## PLANNING BOARD

Tuesday, June 9, 2026 at 4:30 PM  
City Hall, Room 209, 2nd Floor and  
Zoom

**To:** Chair Zamboni & Members of the Planning Board  
**From:** Sean King  
**Date:** June 3, 2026  
**Re:** 15 & 19 Cedar Street  
**Project ID:** PL-003553-2026  
**CBL:** 026 C015001, 026 C014001  
**Meeting Date:** June 9, 2026

Avesta Housing Corporation has submitted a Major Site Plan application for the construction of a five-story, 26,086 square-foot multi-family residential building at 15 & 19 Cedar Street. The proposed development includes 30 dwelling units, of which 100 percent would be deed-restricted affordable dwelling units, along with community spaces for the residents. The property is located in the RN-4 Residential Neighborhood zone. This application is being referred to the Planning Board for compliance with the City of Portland’s Land Use Code Site Plan Standards, Section 13.6.

2 TYP. WINDOW HEAD DETAIL AT BRICK  
3" = 1'-0"

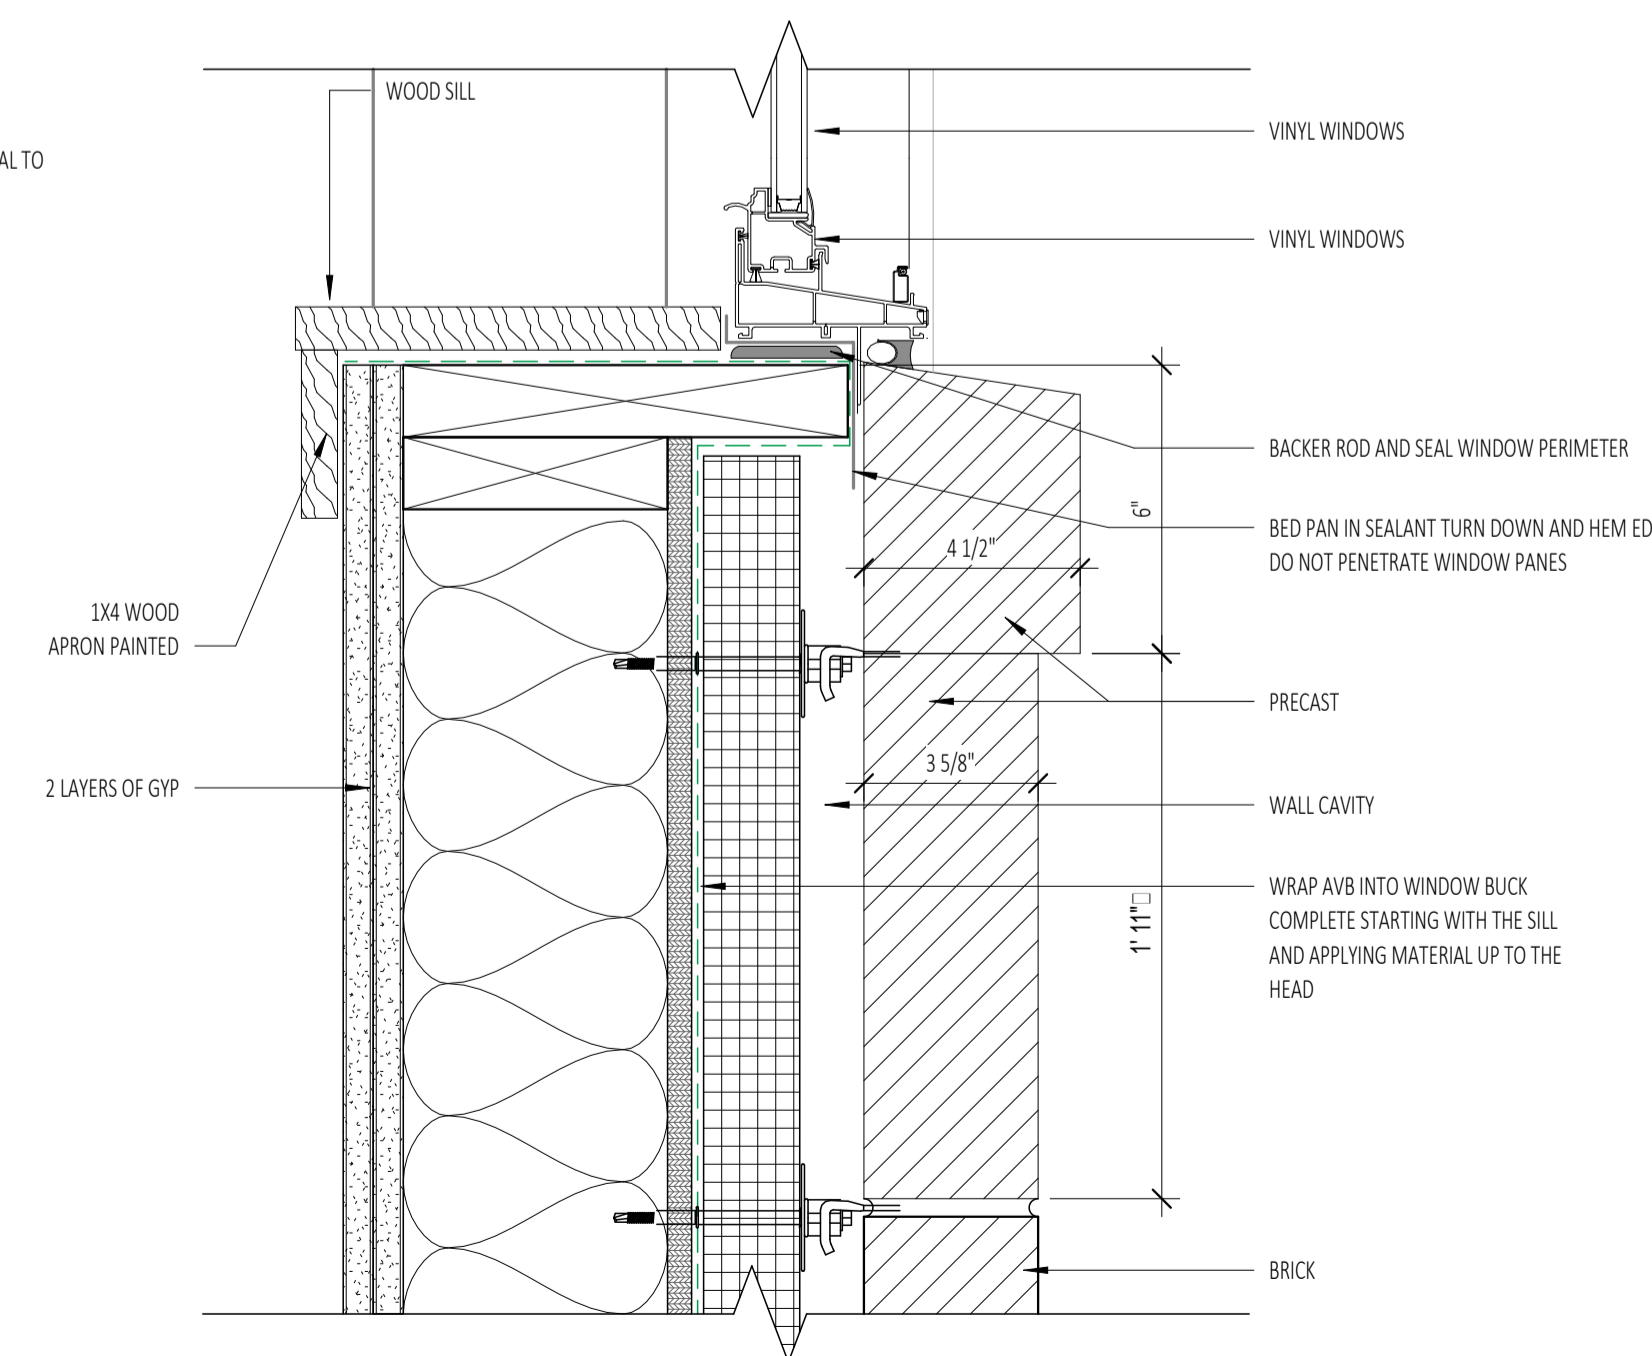
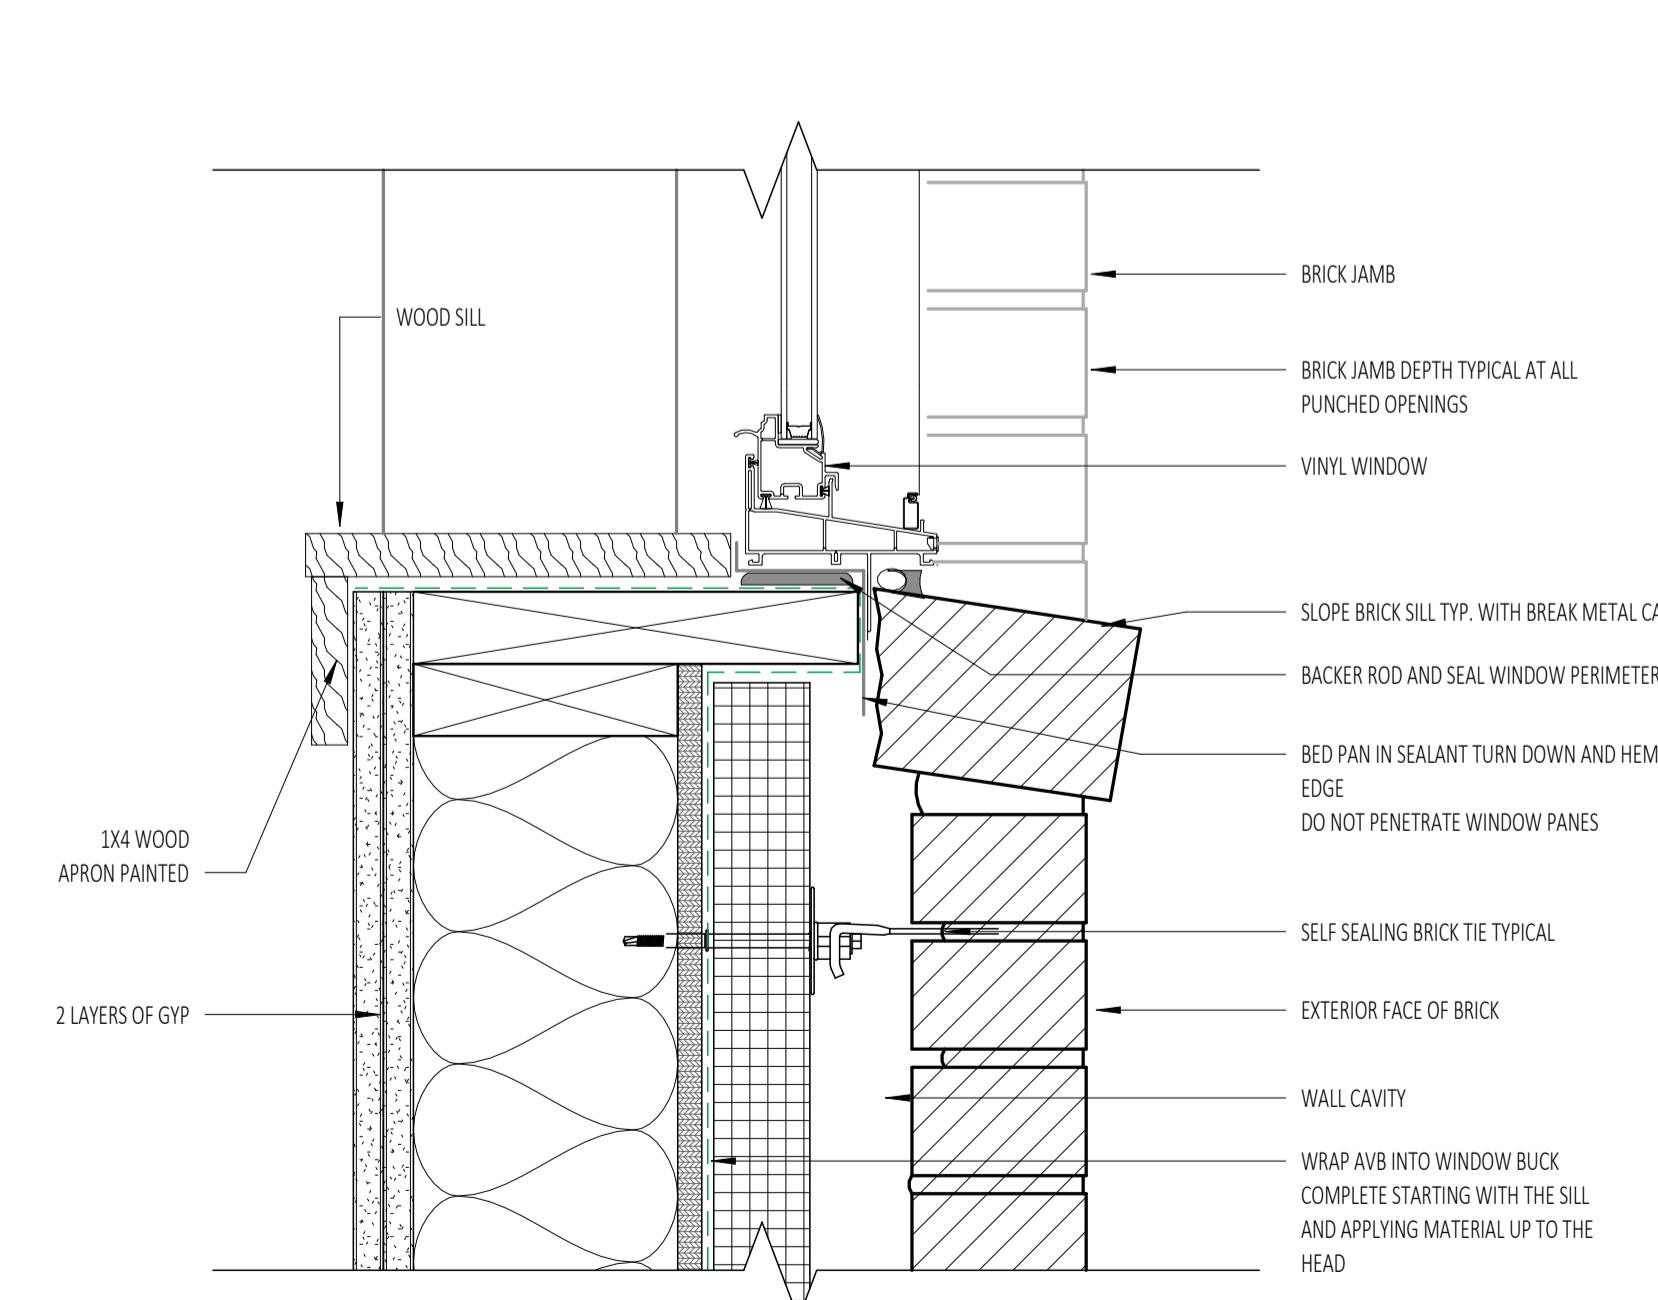
Staff has prepared a design review memo, attachment S4, with comments to provide greater visibility for the recessed entrance at Cedar Street and to specify exterior façade materials onto the architectural elevations.

The requested details have been added to Sheet A5.00. These include vertical window sill, head, and roof cornice details, as well as a horizontal detail addressing the corner trim condition.
